Response to Request for Further Details – A006964285 – 216 Constance Street, Fortitude Valley QLD 4006

Reference is made to Council's request for further details dated 24th April 2026.

Figure 1: Extract from Western Elevation to identify doors (source: Architectus 2026)

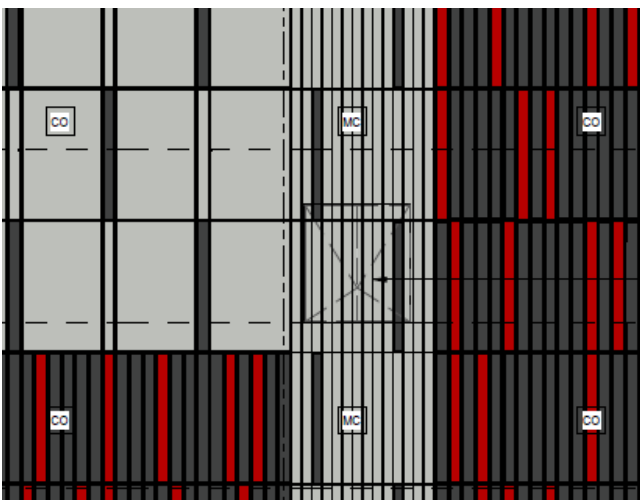
In reviewing the amended façade plan, we understand that Council has also queried the treatment of the proposed doors on the façade side (proposed for equipment replacement). As identified in **Attachment A** (and extracted below in **Figure 1**), the design of the proposed doors has been refined to provide a more cohesive appearance with the surrounding façade, matching the pattern and treatment. The door also has a fire resistance level (FRL) to match the surrounding walls to achieve the necessary compliance.

We also confirm that the doors are not located on the boundary and that there is sufficient space within the site to open outwards without encroaching into the airspace of the adjoining site.
